**NOTICE
OSHTEMO CHARTER TOWNSHIP
PLANNING COMMISSION**

**Regular Meeting
Thursday, February 28, 2019
6:00 p.m.
AGENDA**

Request: Site plan review approval

Project Name: Advia Credit Union Corporate Headquarters

LANDSCAPE PLAN
1"=50'-0"

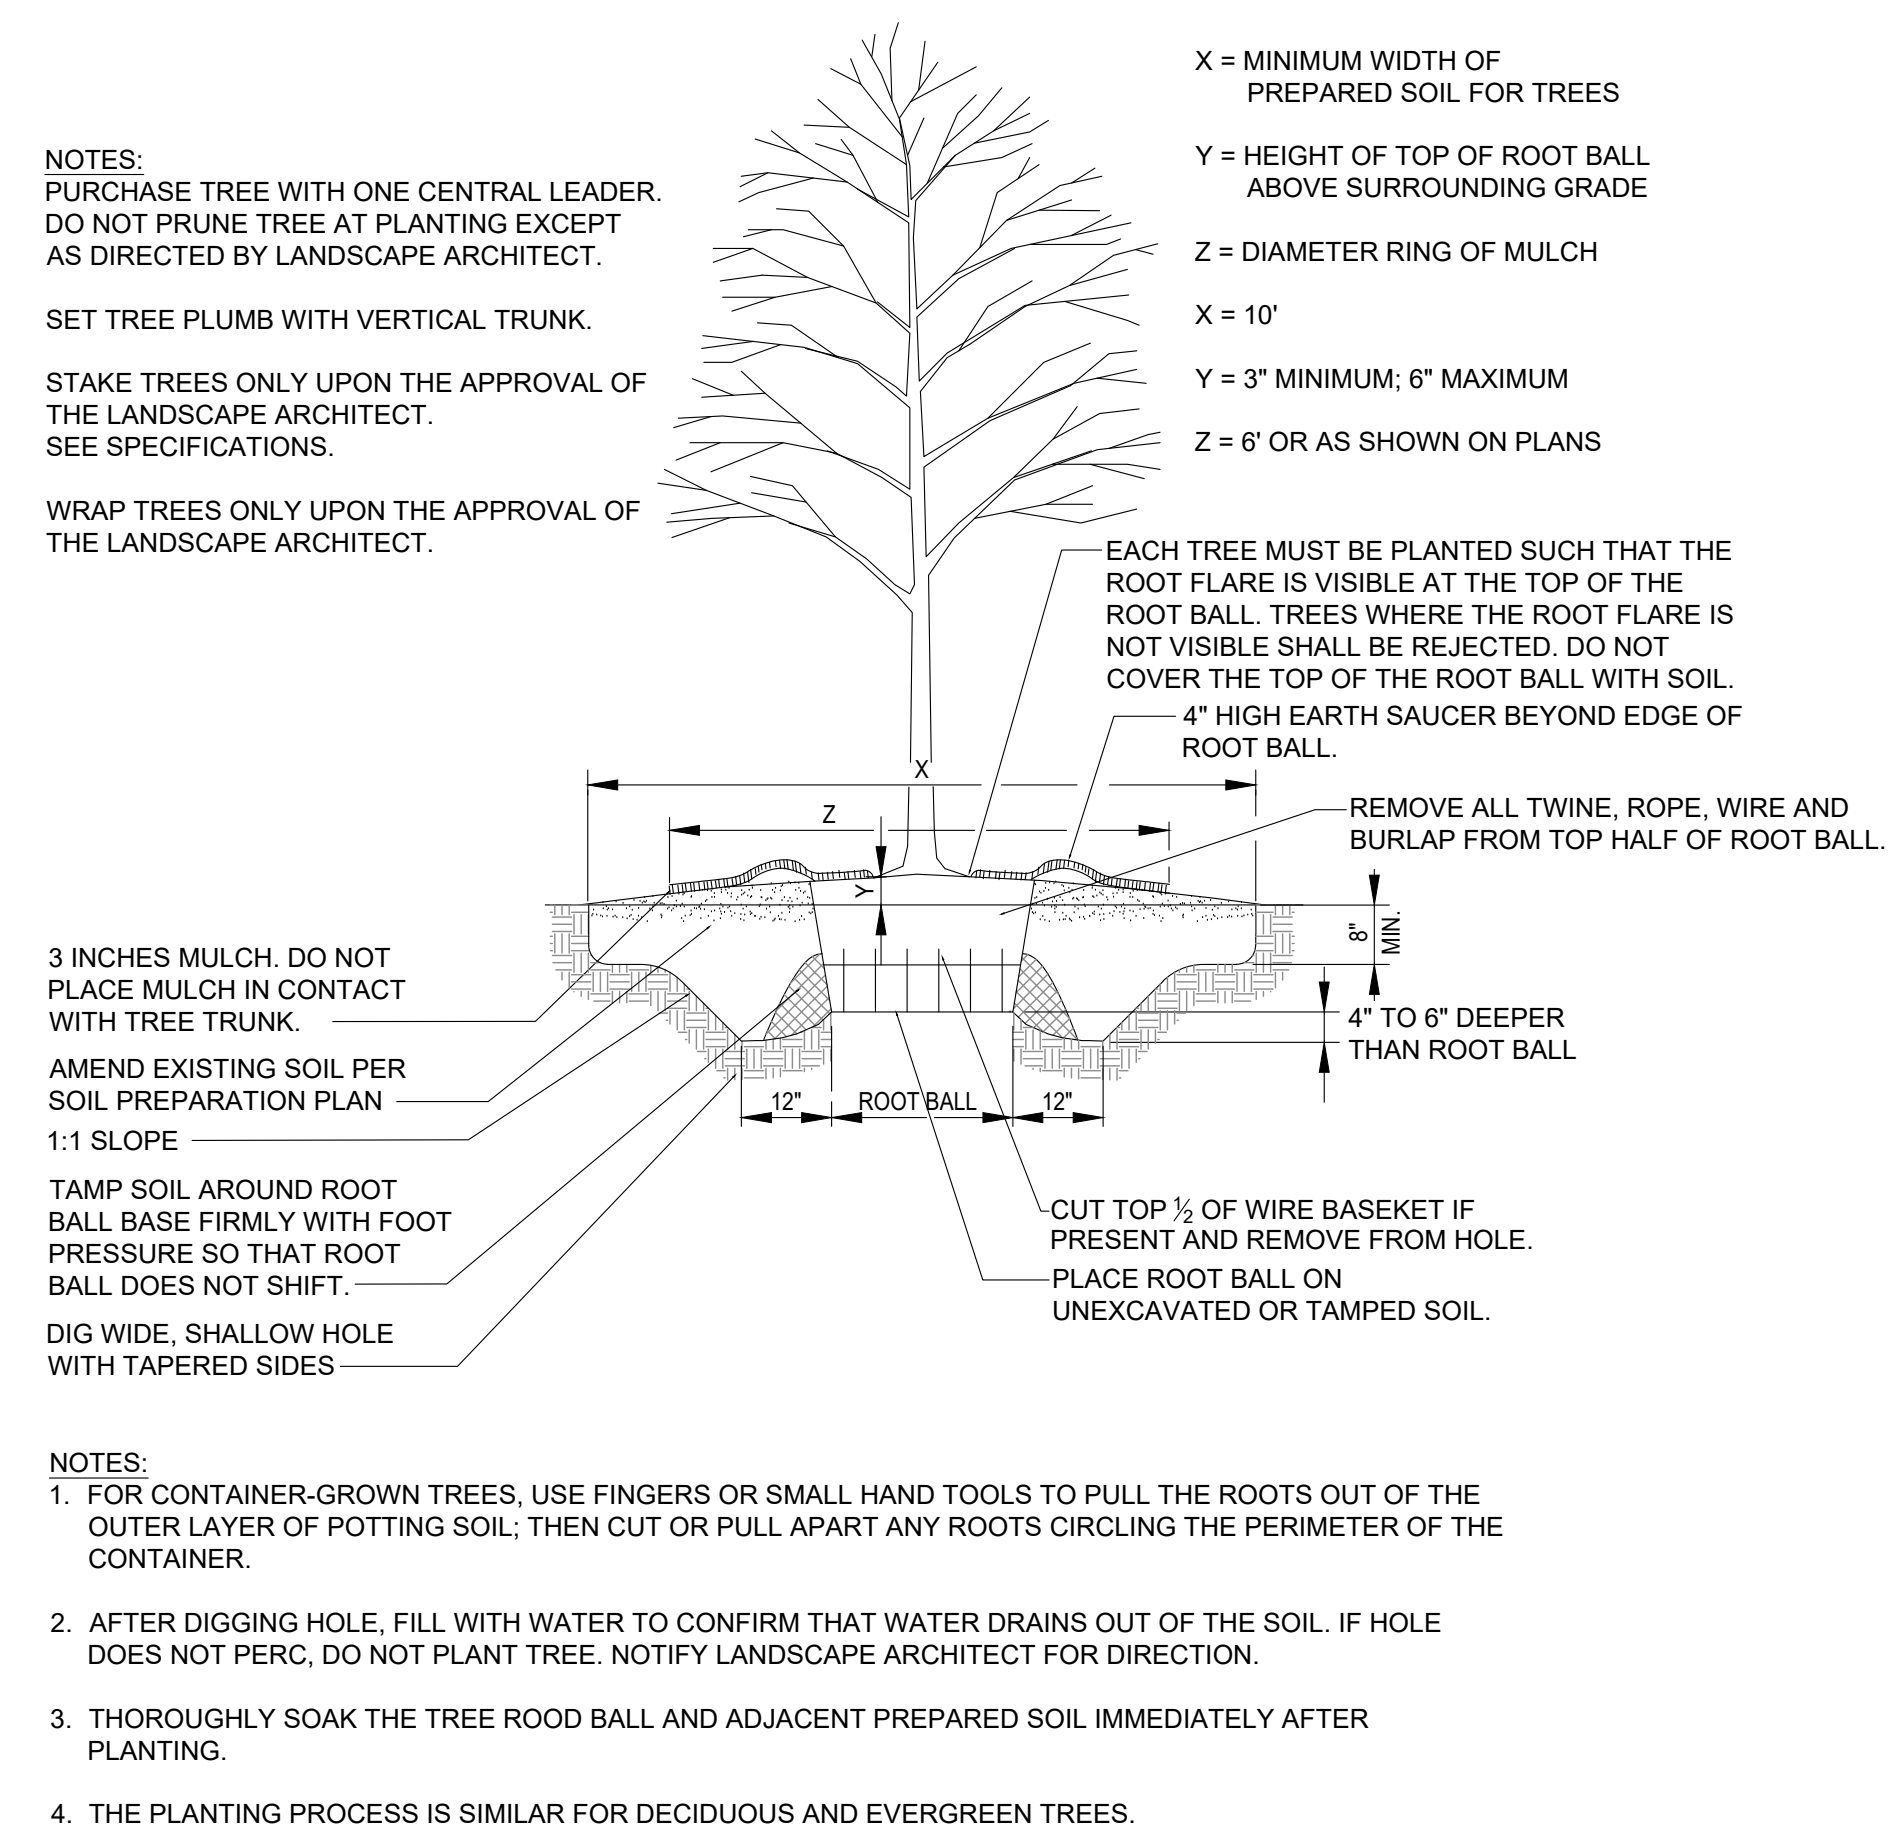
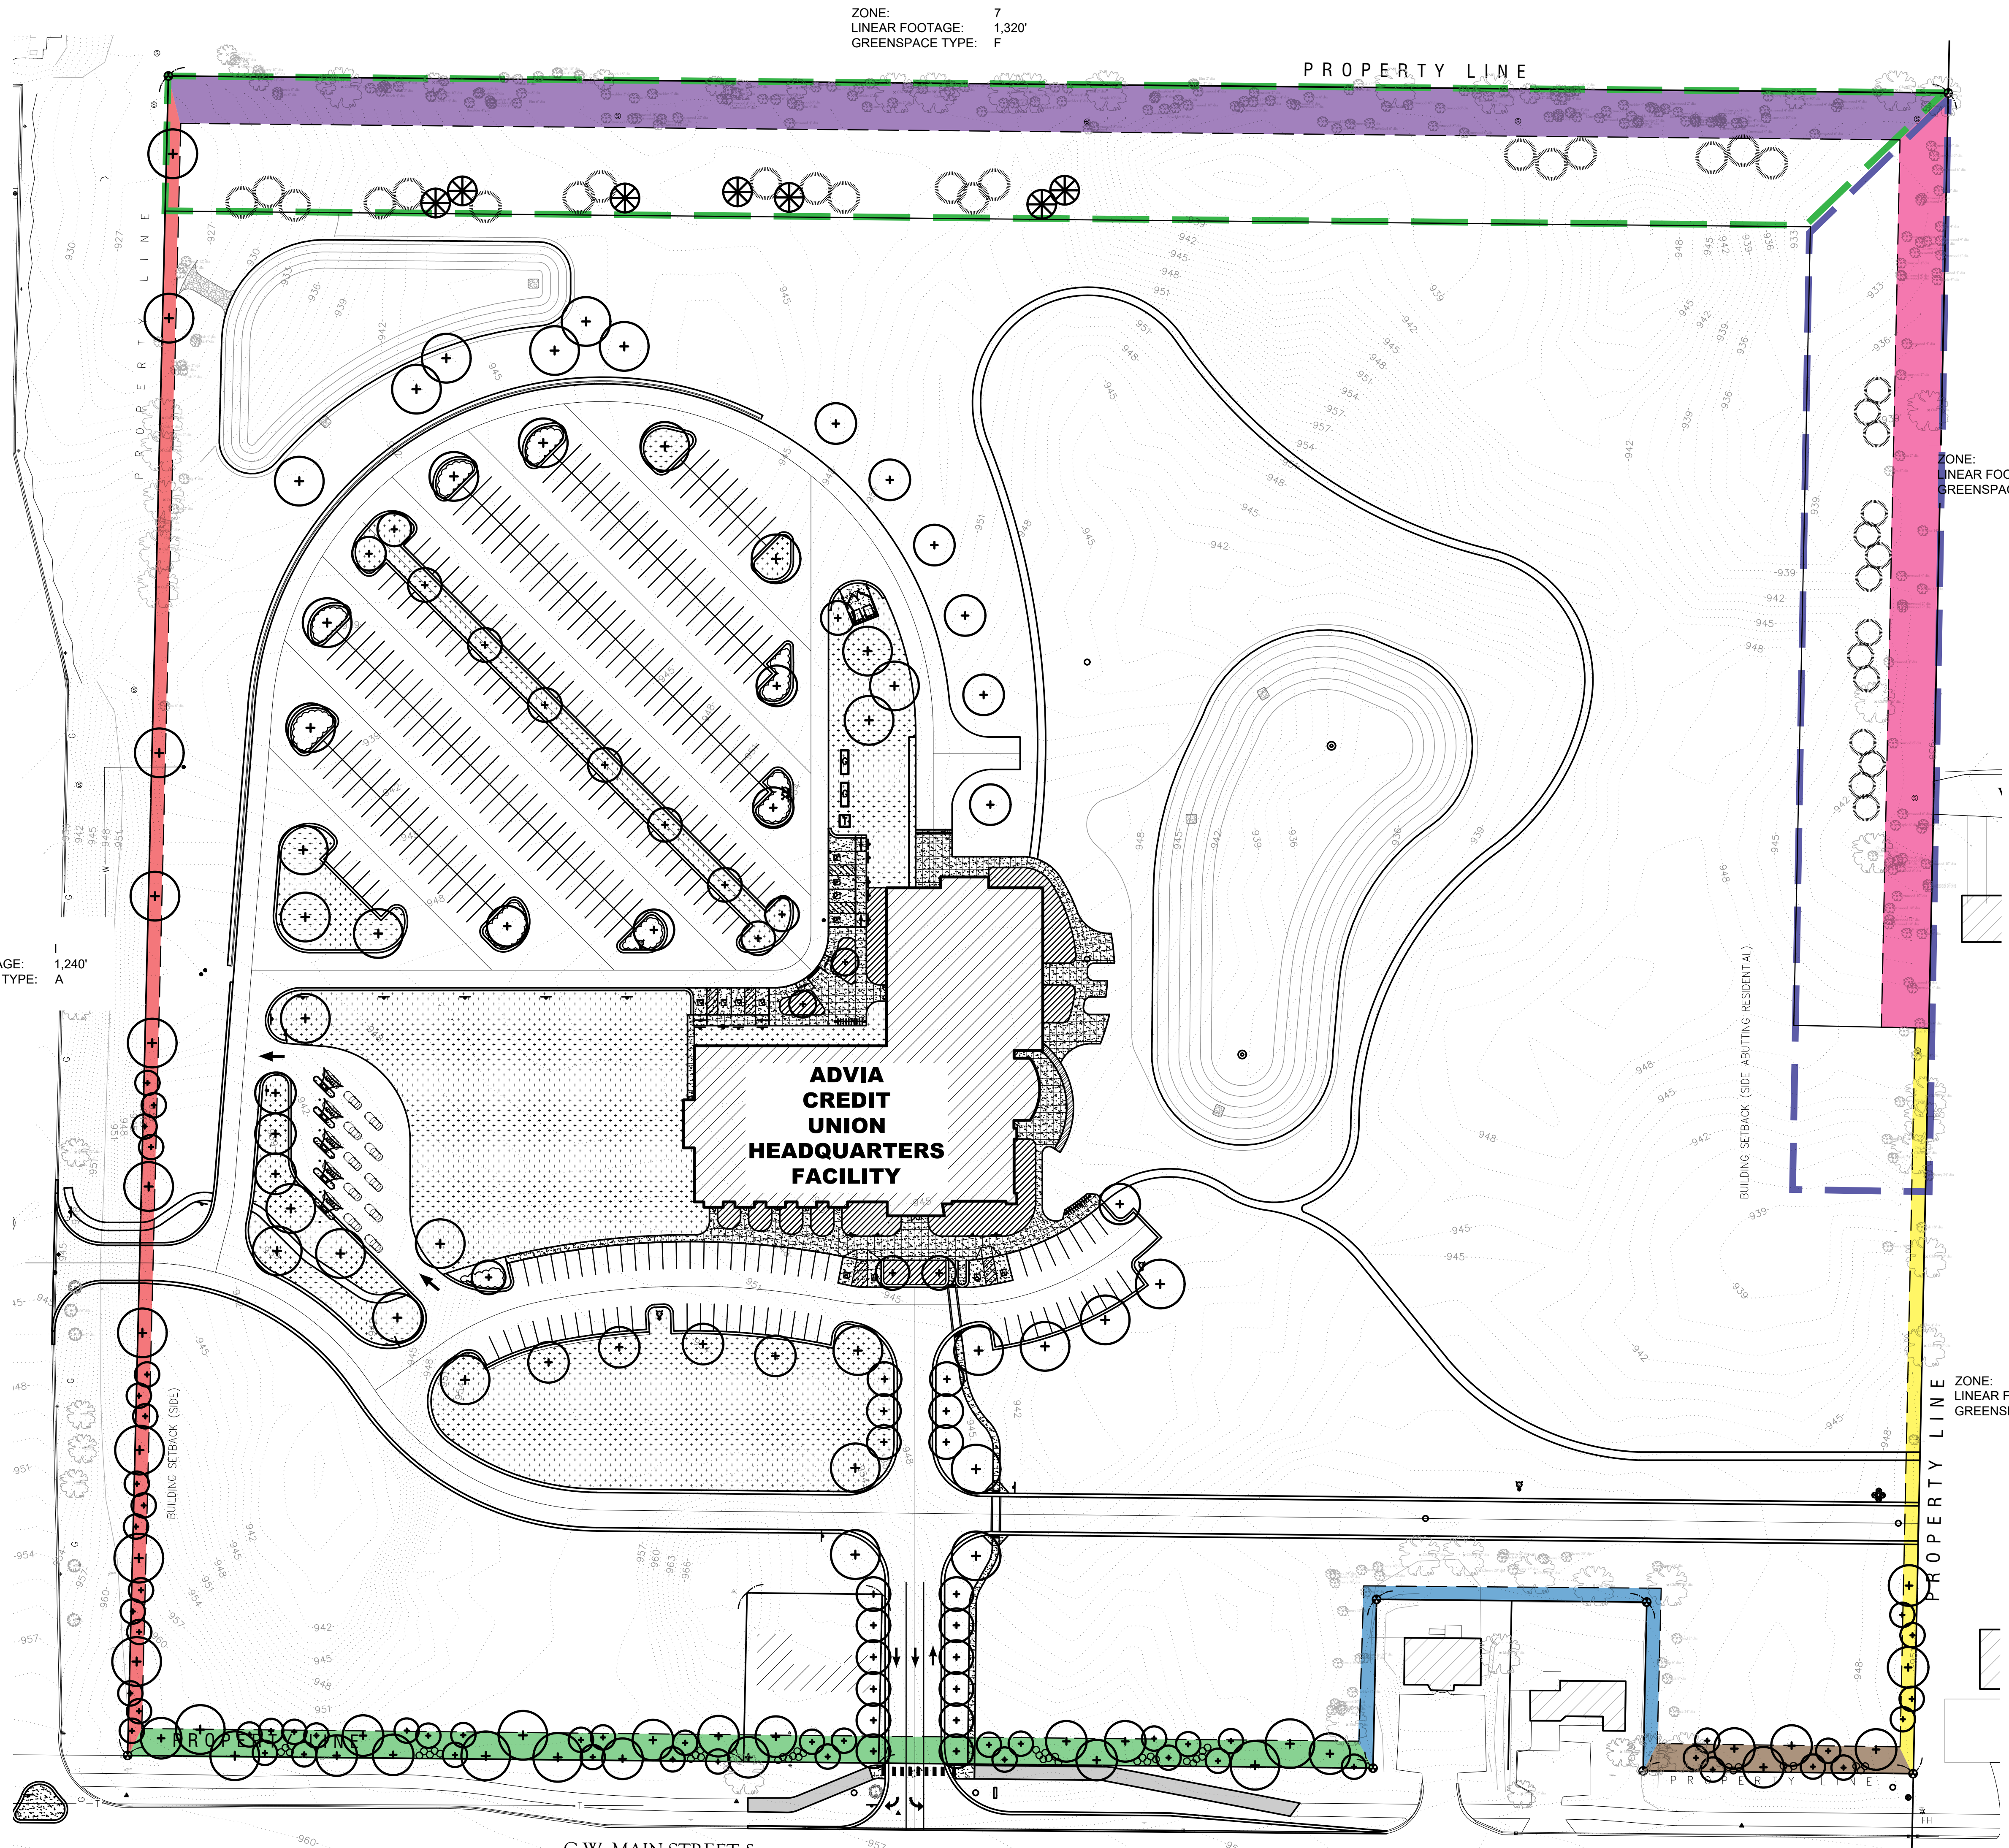
The Landscape Ordinance requires a 20-foot greenspace along West Main Street, a 10-foot greenspace near the adjacent properties that are zoned for nonresidential uses, and a 35-foot greenspace near the adjacent residentially zoned properties. Per the conditions of rezoning, this 35-foot buffer was increased to 100 feet. The applicant will be utilizing *Section 75.200: Preservation of Existing Trees* to calculate tree credits for existing trees on site. These tree credits will preserve existing trees and allow the applicant to plant a reduced number of canopy and understory trees.

The landscape materials required adjacent to the residentially zoned properties includes evergreen trees. The tree survey does not show existing evergreen trees to be used for tree credits. The Township's interpretation of *Section 75.200* is tree credits are given for like trees. Therefore, the required evergreen trees near the adjacent residential zoning is required. The applicant has indicated that because there is an existing 30-foot sewer easement where the 35-foot mandatory buffer zone is located, they are not required to plant the evergreen trees and therefore the trees are not included on the landscape plan.

Section 75.220.B: Exceptions states if a physical hardship exists or existing topography and vegetation are determined by the reviewing body to provide equal or better landscape and buffering effect, the reviewing body may approve modifications only to the planting requirements of *Section 75.130*. The reviewing body may require such alternate plantings and visual screens as hedges, fences, walls, and/or combination thereof which it deems necessary to ensure compliance with the spirit, purpose and intent of this Section. Since the conditional rezoning requires a 100-foot buffer adjacent to the residential neighbors, staff feels there is ample room in this area to meet the evergreen tree requirement.

The following rezoning conditions are outlined on sheet L100, L110, and L120, Landscape Plans. Staff's comments are indicated below each condition.

The applicant would like to utilize the existing topography of the site to meet the berm requirement. They intend to provide graphics that will help to support their argument. One such graphic is included with this memo and the remaining graphics will be provided prior to the meeting date. The Planning Commission will need to determine if the spirit and intent of this condition has been met.

- The Planning Commission will need to determine if the undulating berm required by the conditional rezoning is met through the topography of the site or must be installed as part of the 100-foot buffer.

4. An updated landscape plan that includes the evergreen trees required by *Section 75.130*, which must be installed within the 100-foot buffer area.
5. The lighting specifications for the building and architectural pole lighting be provided to the Township.
6. An updated photometric plan that includes a note that all lighting will be full cut-off and downward directed.
7. An updated photometric plan that includes information related to reduced lighting during non-business hours.
8. Any final concerns from the Township Engineer will be resolved.
9. Any final concerns from the Township Fire Marshal will be resolved.

As part of this motion, the Planning Commission will need to determine if the undulating berm required by the conditional rezoning is either met through the topography of the site or must be installed as part of the 100-foot buffer. If the Planning Commission determines the berm should be installed, staff recommends the following additional condition:

10. An updated landscape plan that shows the placement of the undulating earthen berm of varying heights, but not above six feet, constructed with slopes not to exceed a one to three gradient either in, or adjacent to, the 100-foot buffer zone. The berm shall be covered with sod, seed, or a natural ground cover.
